Floyd County Redevelopment Commission Meeting

Subject: EDA Project No. 06-01-06148  
Change Order Review

**ECONOMIC DEVELOPMENT ADMINISTRATION  
 CHANGE ORDER FORM**

Innovation Parkway Phase 2 & 3

WATERPROOFING MEMBRANE DETAIL  
Scale: 1/4" = 1'-0"

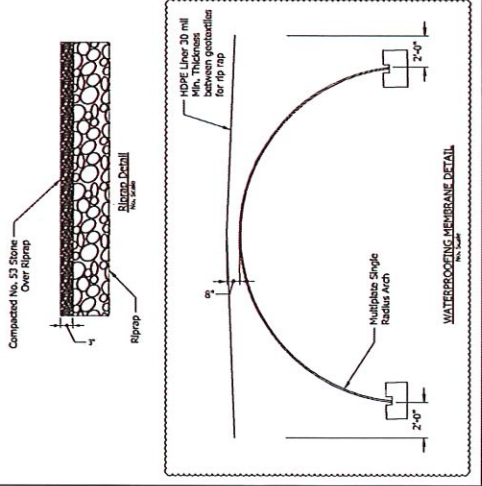
Waterproofing Membrane Detail Added

**STRUCTURE 1**  
 COLOR CODE: RED

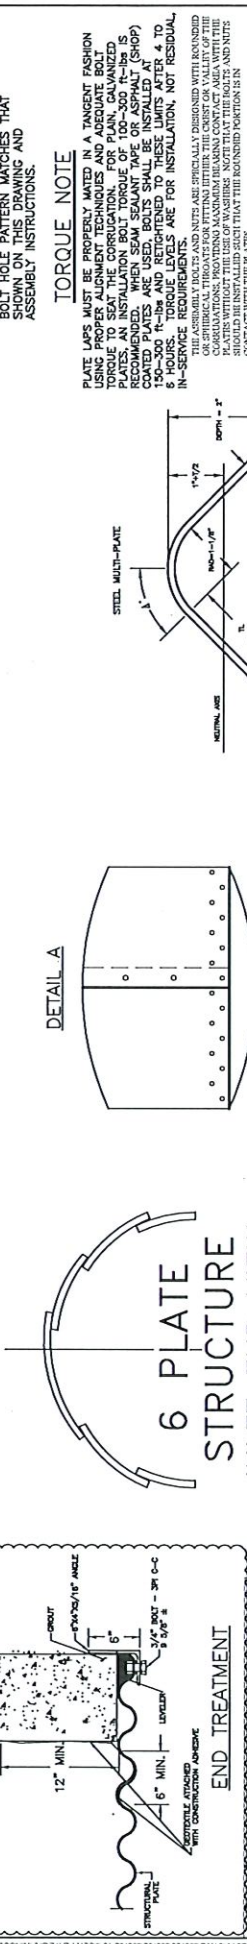
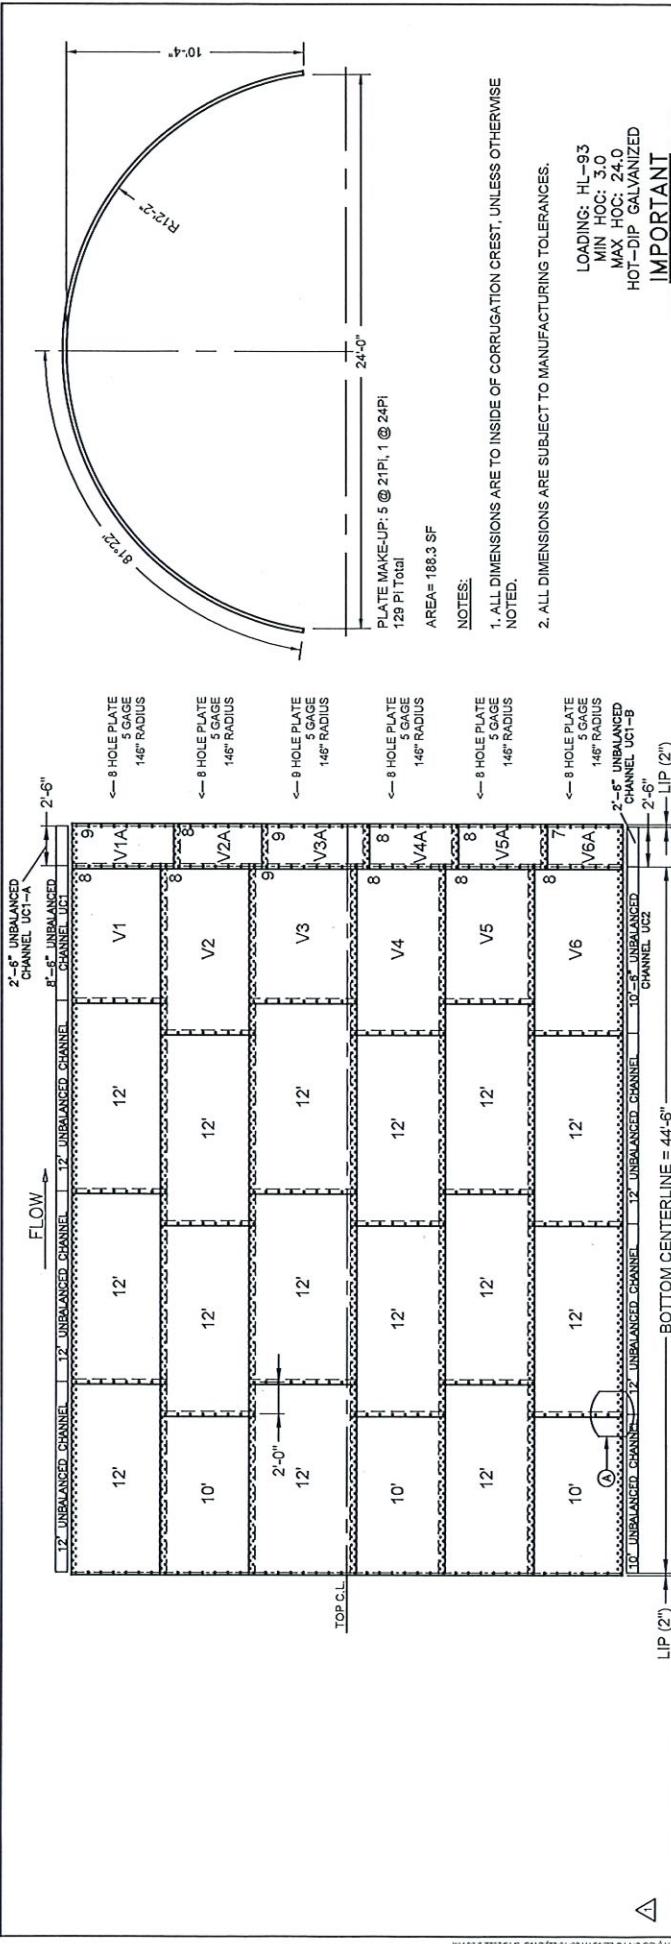
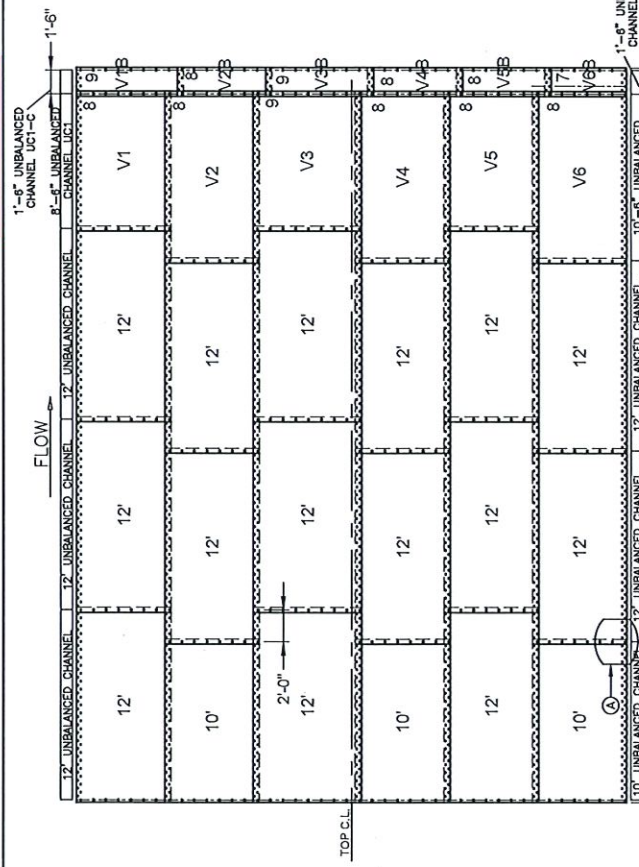
CO #2 covers the cost of producing and installing custom Structural Plate Arch extension panels onto the ends of the three original planned arches embedded through MSE Walls 4 and 5.  
 Change Order Justification (Include cost analysis, if not unit cost in bid proposal or schedule of values):

NO.	DATE	REVISION DESCRIPTION
1	07/20/21	MSE WALL; MEMBRANE; FOOTING CALL OUT
2	10/12/2021	UNBALANCED CHANNEL DETAILS
3	3/16/2022	LENGTH ADD ON

Attached are the revised drawings for the pipe arches, showing the revised length that our engineers came up with, based on the approved MSE walls 4,5 and 6. I have also listed the length of the structures at the wall. Since the arch is constructed "square", the longest length has to be accommodated. Let me know if you have any questions. This would be an overrun of the item for the arches, but the additional per foot price is not enough to cover the additional cost to make the extensions. That is because they are not a standard size, and it looks like they will have to do a couple special setups to make the short extensions. Once I get all the pricing I will get it to you.

PLATE LAYOUT --- OUTSIDE VIEW  
 STRUCTURE 3

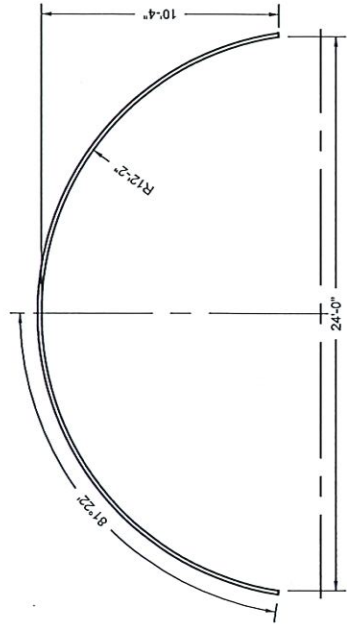
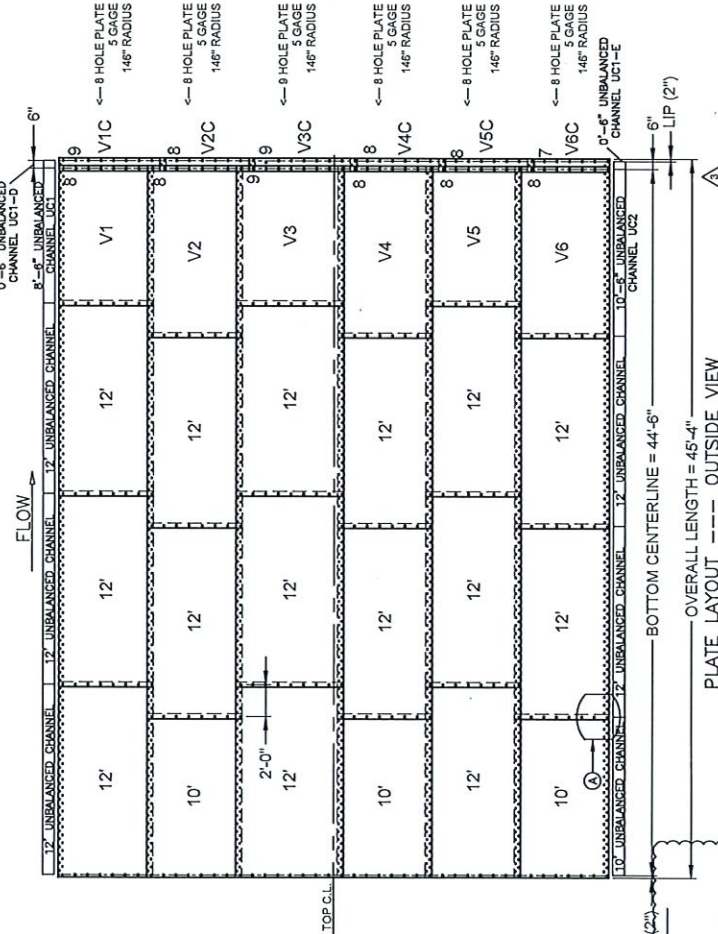
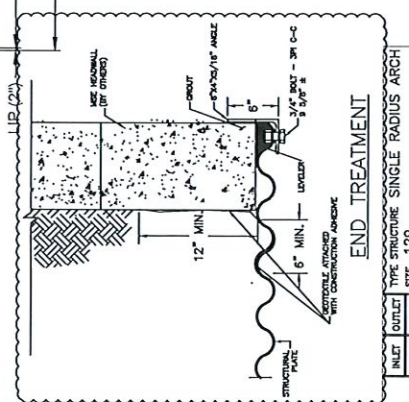
NO	DATE	REVISION DESCRIPTION
1	9/7/2021	MISE WALL; MEMBRANE; FOOTING CALL OUT
2	10/12/2021	UNBALANCED CHANNEL DETAILS
3	3/16/2022	LENGTH ADD ON
